Rolling Meadows Substation
Construction of a New Electrical Substation
including Grading, Drainage, and Surface Improvements
El Paso County, Colorado

EPC STORMWATER REVIEW COMMENTS
IN ORANGE BOXES WITH BLACK TEXT

Dwn: TMC		Date: 06/22/26	
Appd: DWS		Date: 06/22/26	
DWS			
S1183-A-01-001			
Tri-State Generation and Transmission Association, Inc. 1100 W. 116th Ave. P.O. Box 33895 Denver, Colorado 80233 303-452-6111		Rolling Meadows Substation Facility Civil Sheets S1183-A-01-SHEETS.dwg	
ROLLING MEADOWS SUBSTATION 115/12.47KV COVER SHEET		TRI-STATE GENERATION & TRANSMISSION ASSOCIATION, INCORPORATED	
UPDATED BY: WLUOGATE		6/19/2026 9:37 AM	
Contract: 4713		No.	
		Date	
		Dwn.	
		Appd.	
		Revision	
		M.F.	
		Dwg. No.	
		Mfr.	
		Reference Drawings	
		Drawing Title

ROLLING MEADOWS SUBSTATION 115/12.47KV GRADING PLAN

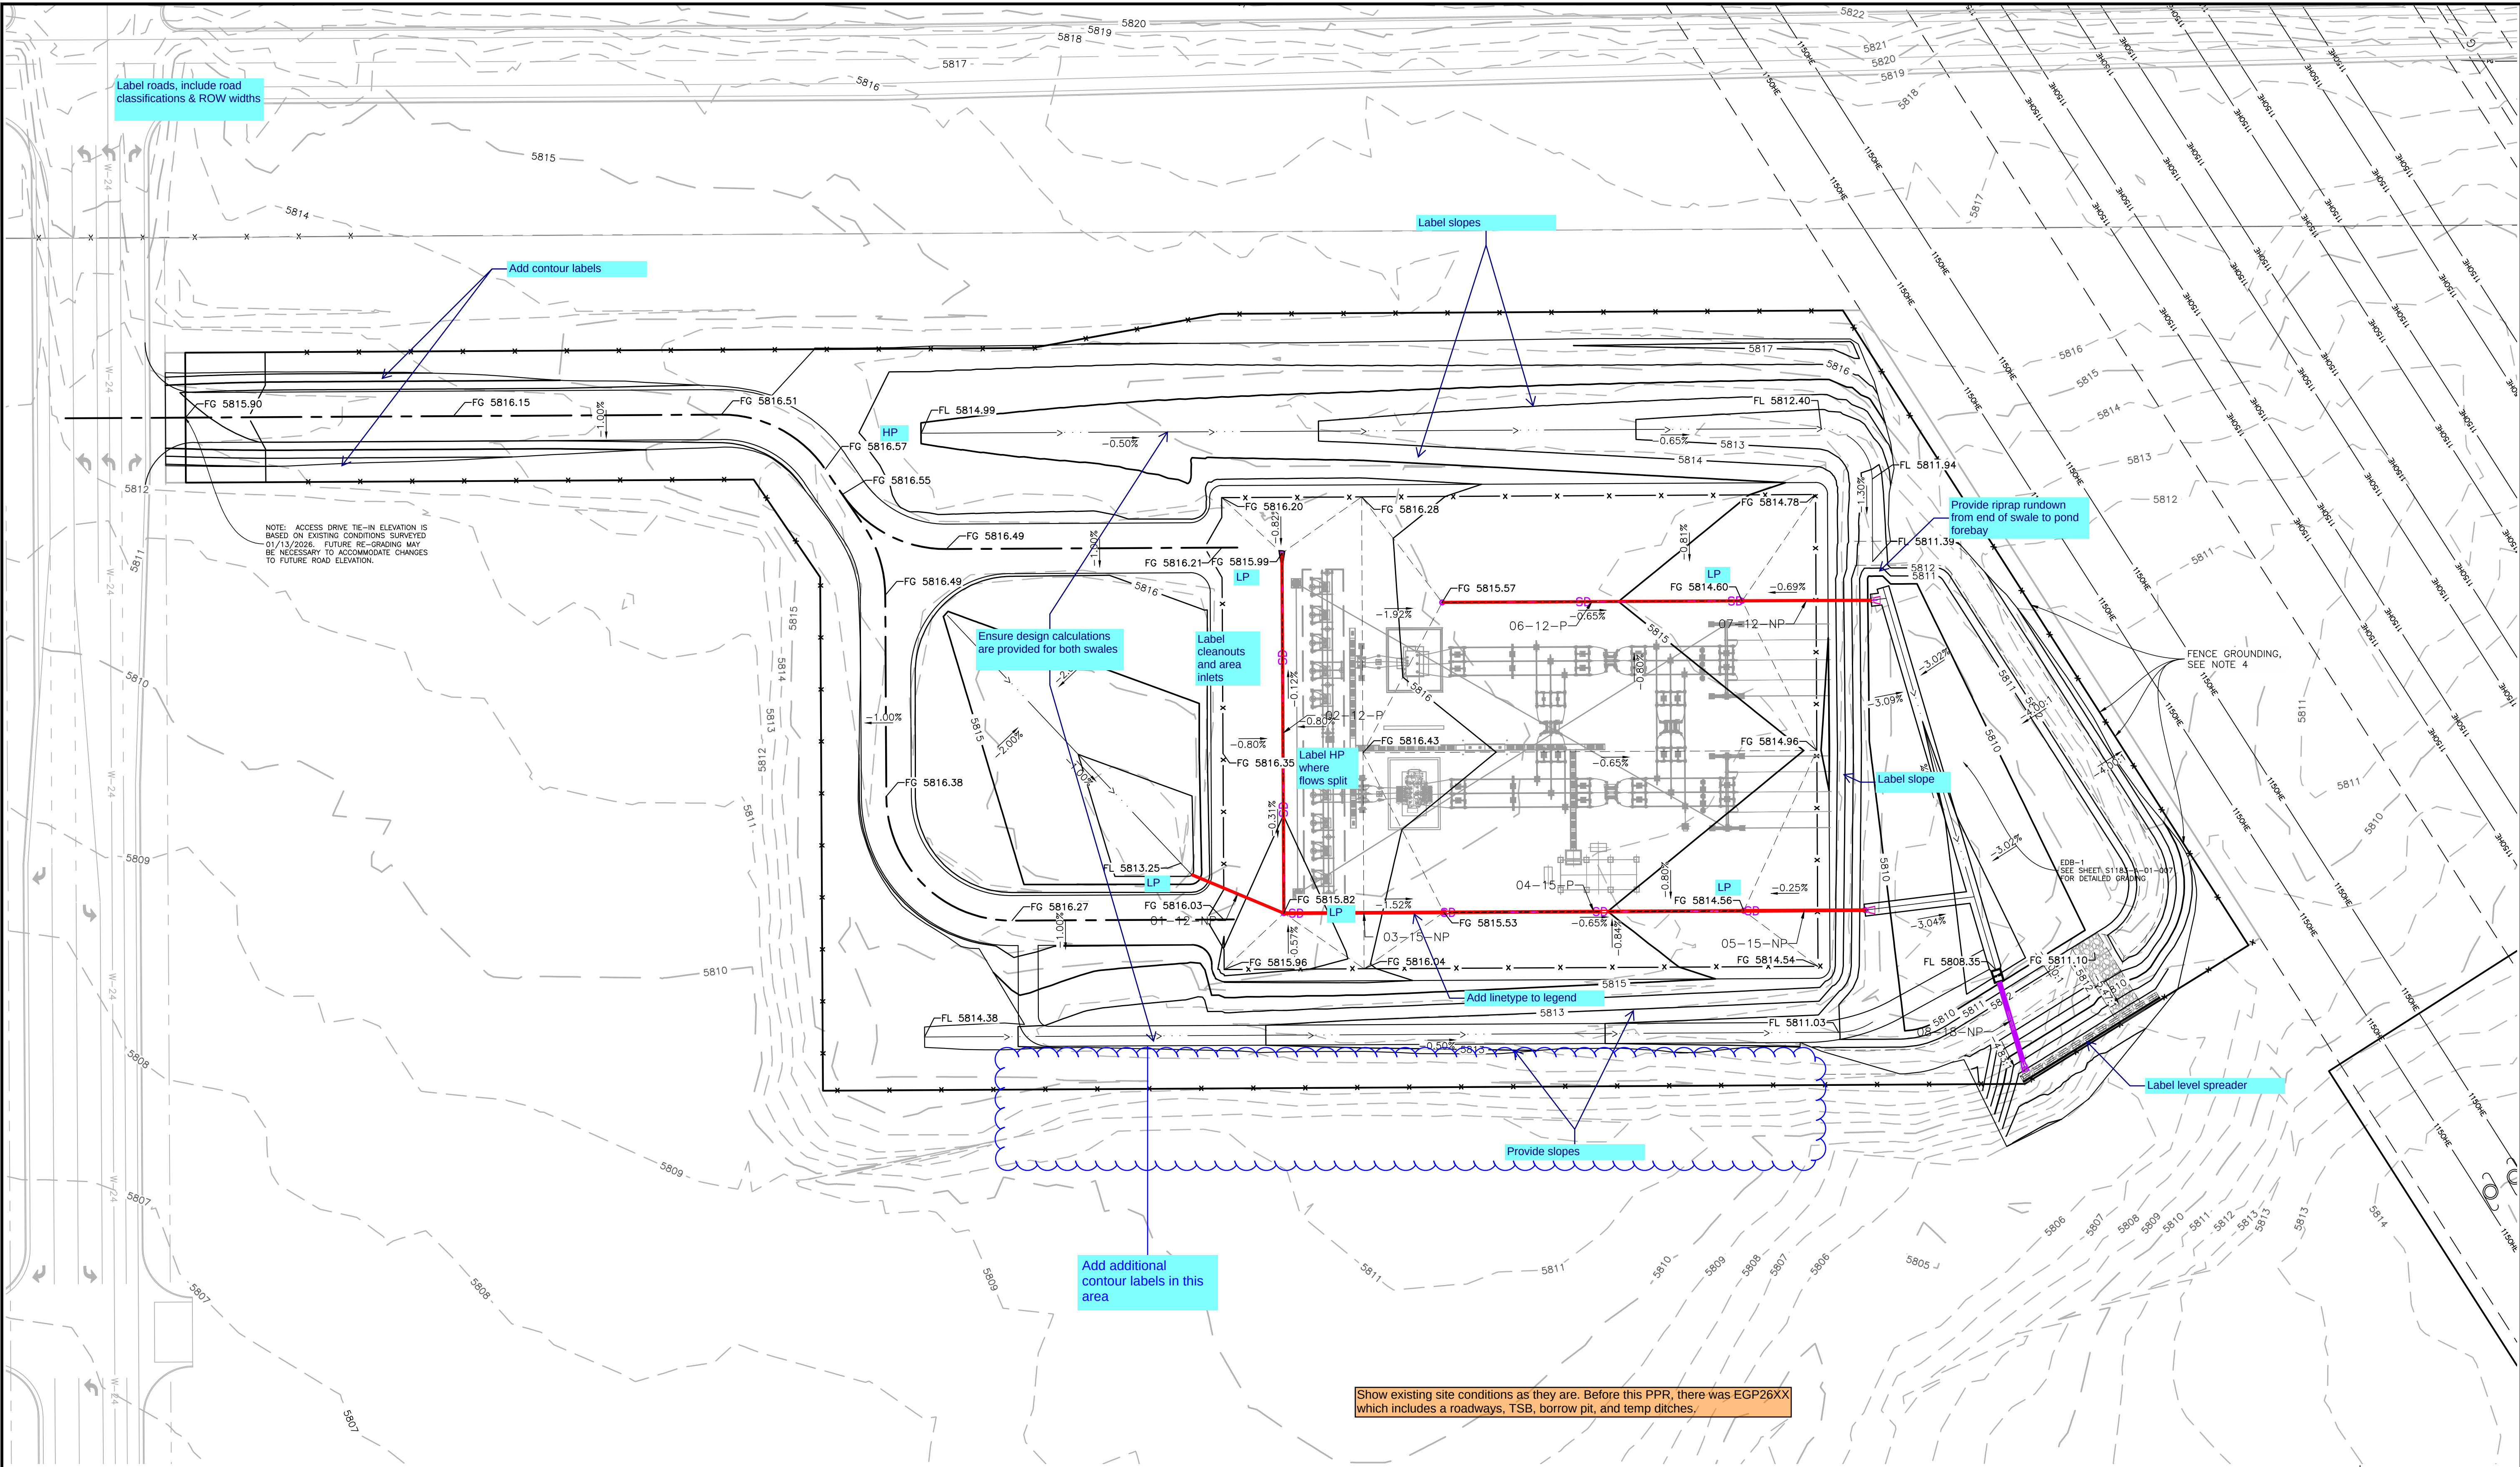
Label roads, include road classifications & ROW widths

Add contour labels

Label slopes

Ensure design calculations are provided for both swales

Label cleanouts and area inlets

Label HP where flows split

Add linetype to legend

Provide slopes

Add additional contour labels in this area

Provide riprap rundown from end of swale to pond forebay

Label level spreader

Add linetype

115/12.47KV
SUBDRAIN PLANS

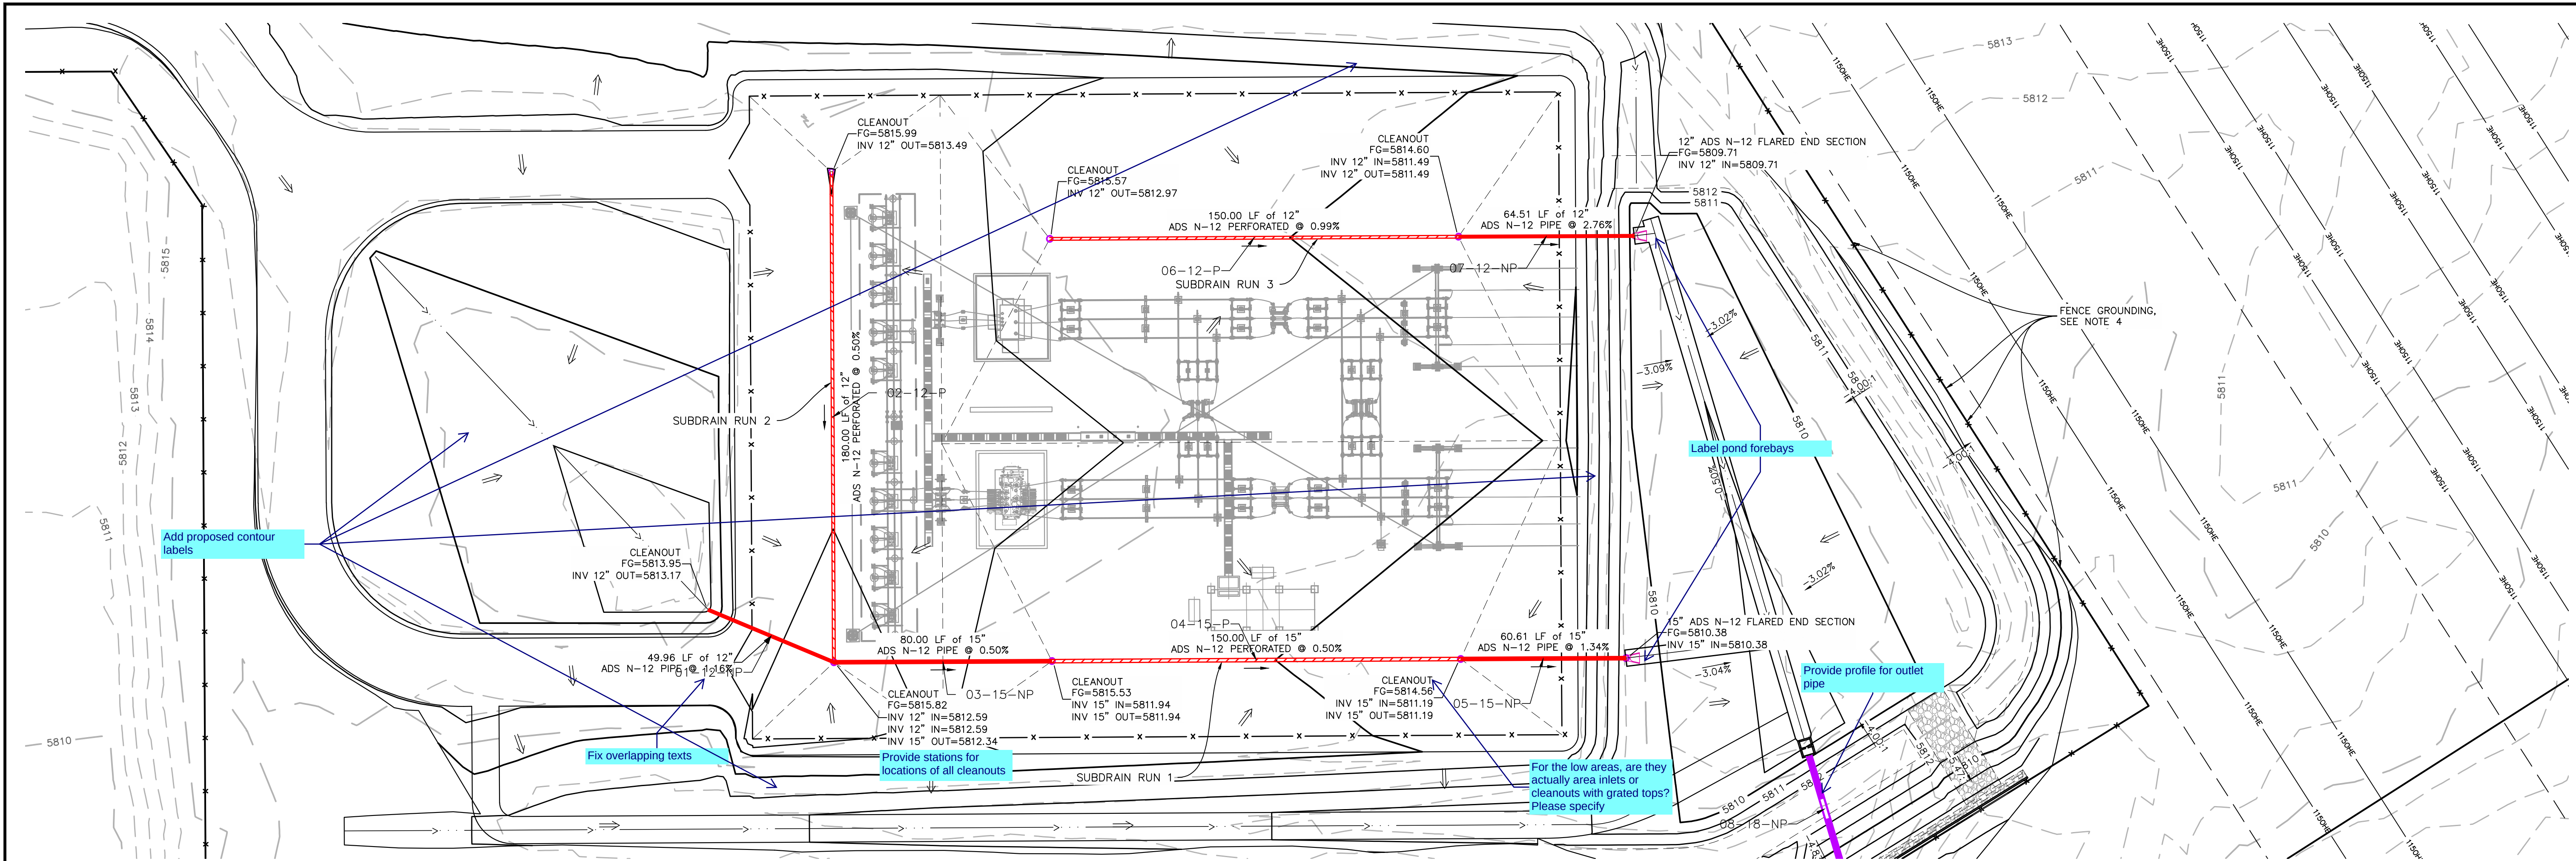
Indicate or add note that system is private.

EDB-1 GRADING

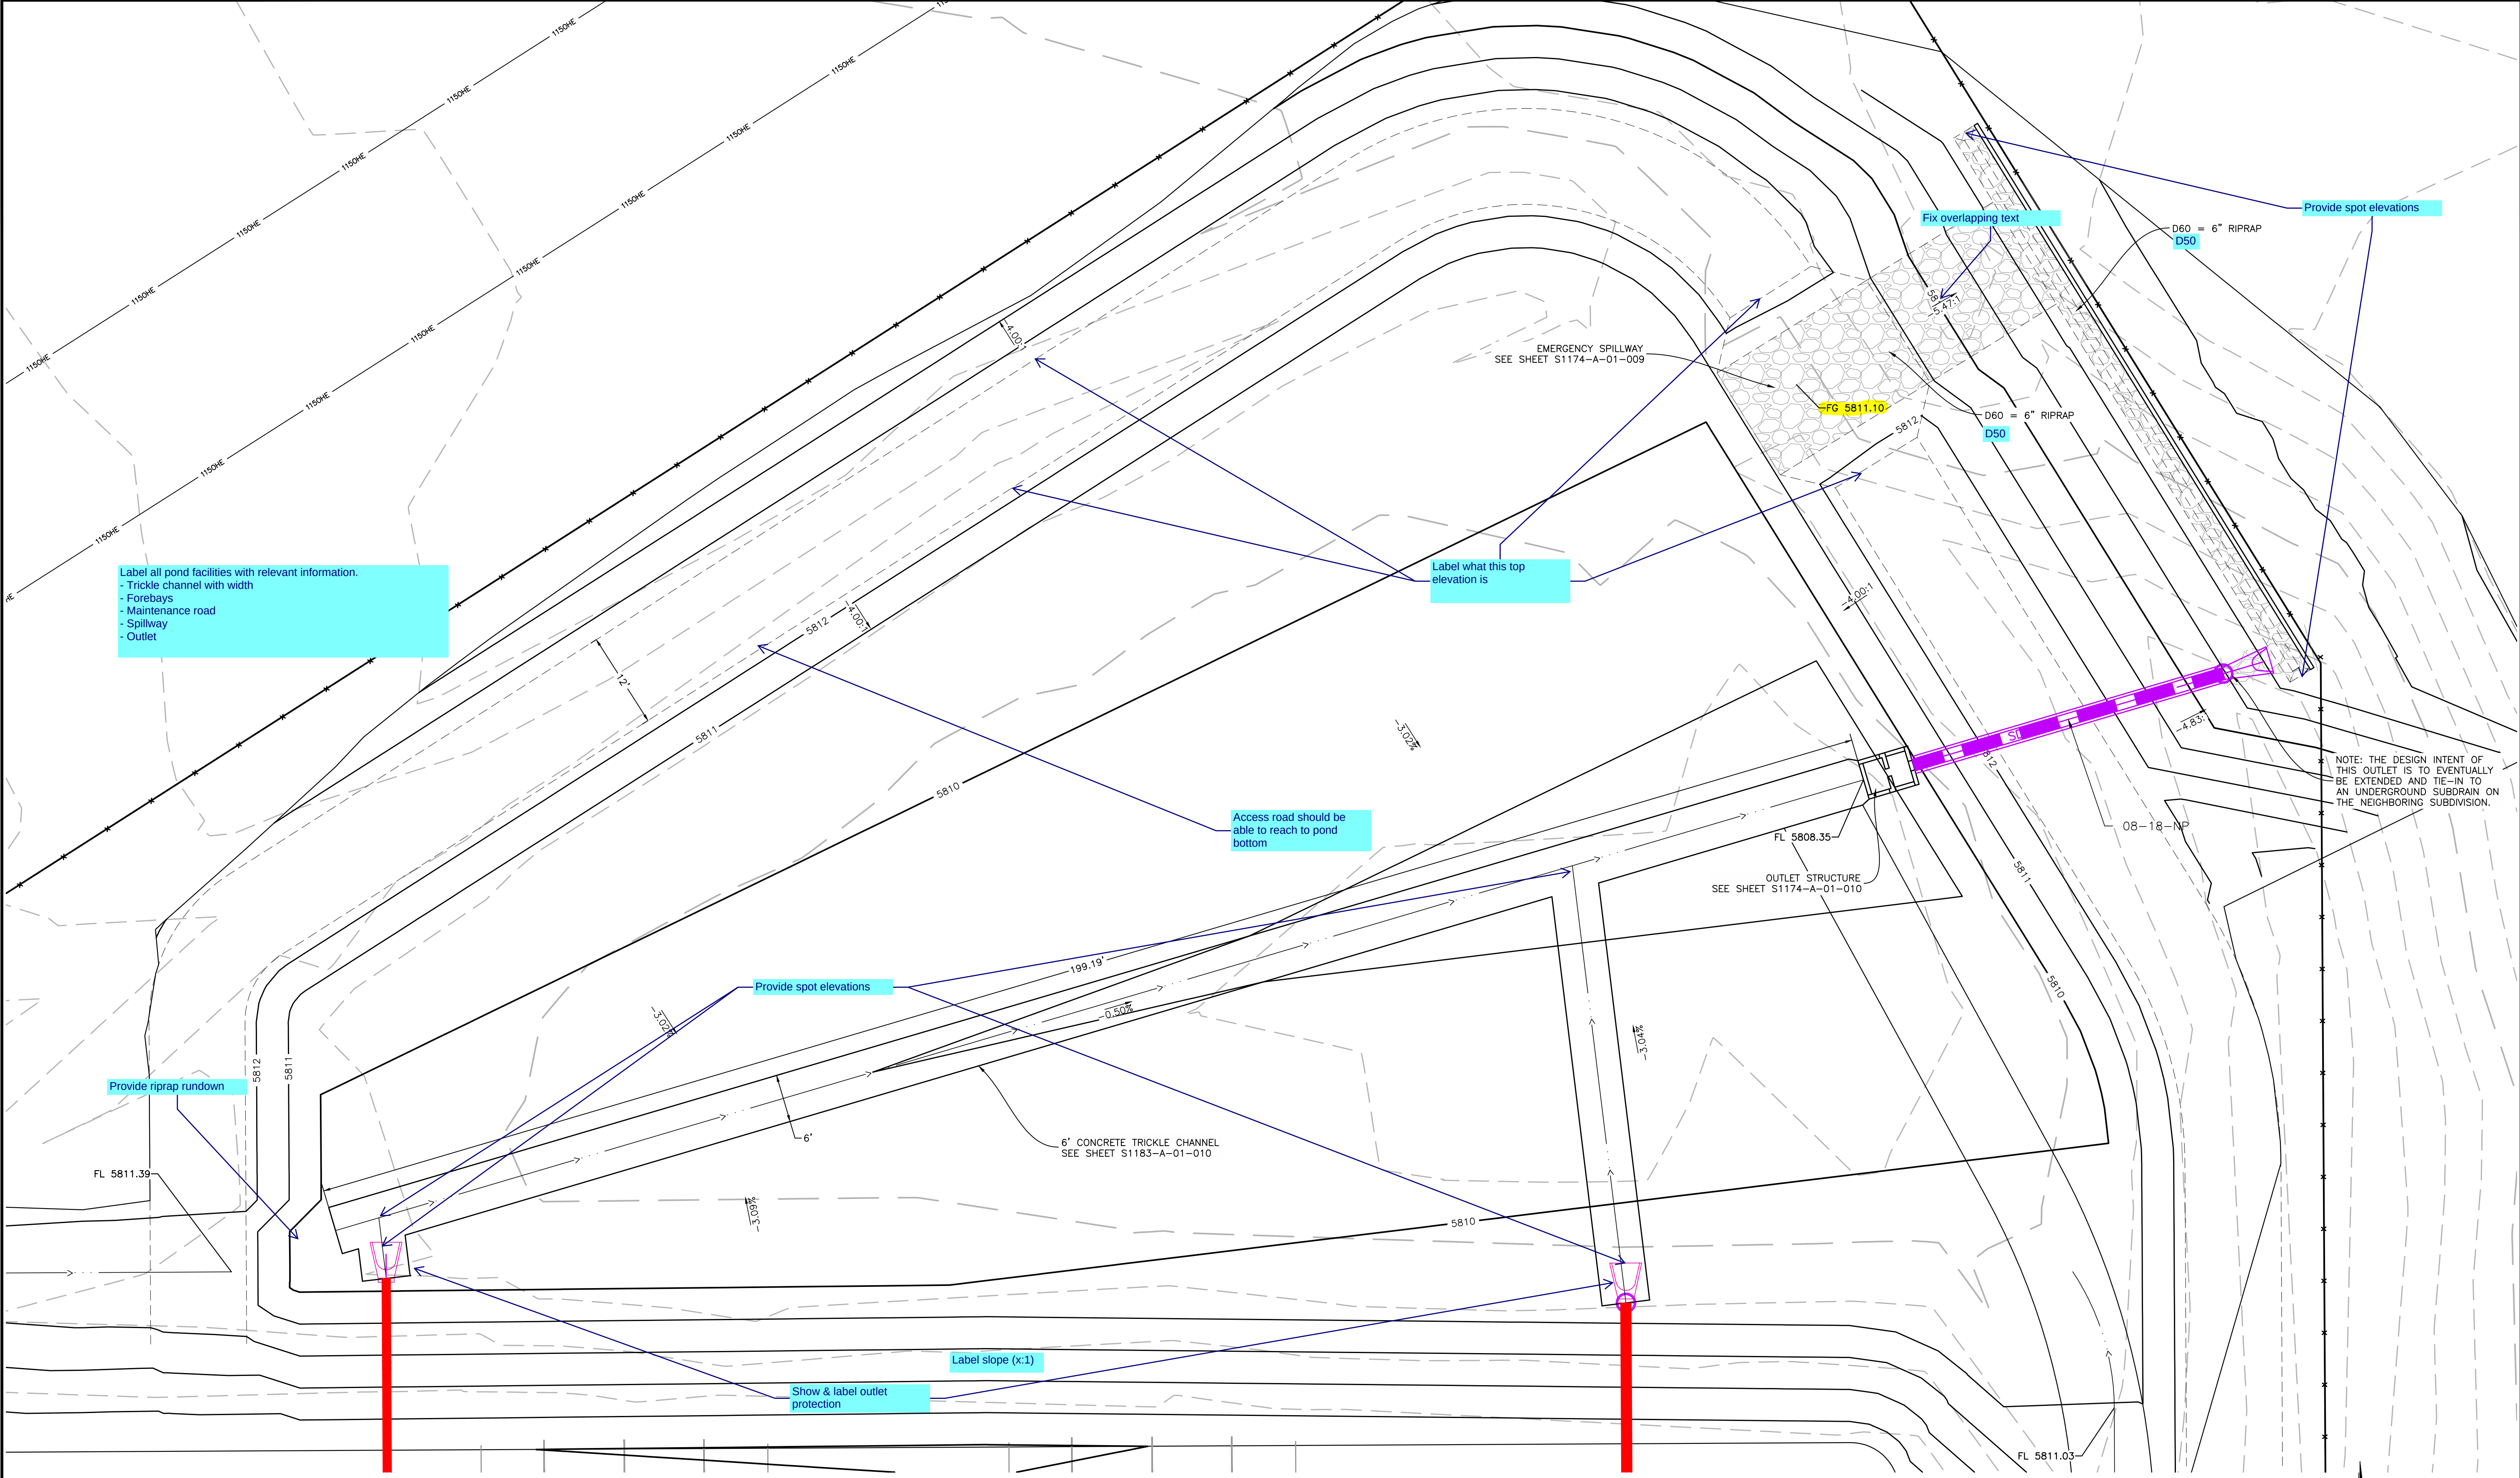
Show maintenance roadway in planview

TYPICAL DRIVEWAY SECTION
N.T.S.

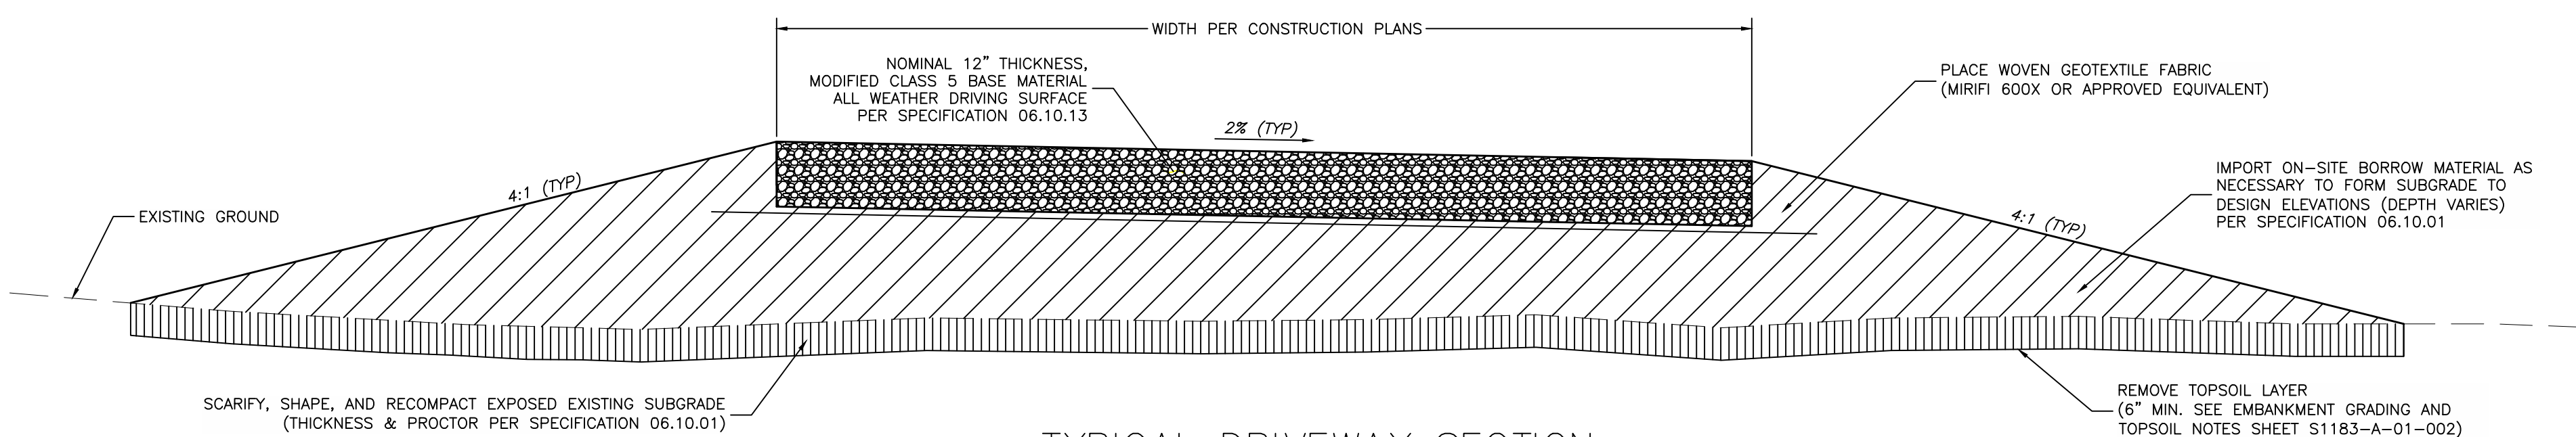
Provide driveway section for paved portion (first 50' of drive)
